CORPORATION OF THE TOWNSHIP OF ESQUIMALT

DATE: September 27, 2022 Report No. DEV-22-091

Development Variance Permit & Development Permit - 856 & 858 Esquimalt Road

Figure 1.

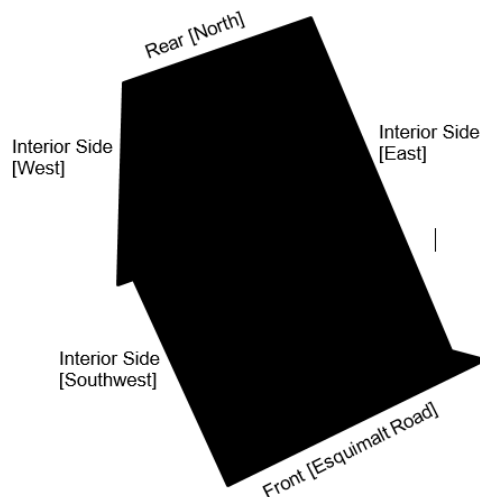
Within this CD-80 Zone, lot lines and setbacks shall be determined in accordance with Figure 1 (below).

- (i) No Building shall be located within 7.1 metres of the Front [Esquimalt Road] Lot Line.
- (ii) The northwest wing of the southern Principal Building [Building A] shall not be located within 4.3 metres of the Interior Side [West] Lot Line.

- (iii) The southwest corner of the southern Principal Building [Building A] shall not be located within 3.1 metres of the Interior Side [Southwest] Lot Line.

- (iv) The western wing of the southern Principal Building [Building A] shall not be located within 11.9 metres of the Interior Side [East] Lot Line.
- (v) No Building shall be located within 7.5 metres of the Rear [North] Lot Line.

- (vi) The northern Principal Building [Building B] shall not be located within 7.7 metres of the Interior Side [East] Lot Line.
- (vii) The northern Principal Building [Building B] shall not be located within 6.4 metres of the Interior Side [West] Lot Line.

- (viii) The separation between the east wing of the southern Principal Building [Building A] and the south wing of the northern Principal Building [Building B] shall not be less than 17.5 metres.

- (ix) The separation between the northwest wing of the southern Principal Building [Building A] and the west wing of the northern Principal Building [Building B] shall not be less than 12.5 metres.

- (x) The separation between the northwestern wing of the southern Principal Building [Building A] and the south wing of the northern Principal Building [Building B] shall not be less than 20.0 metres.
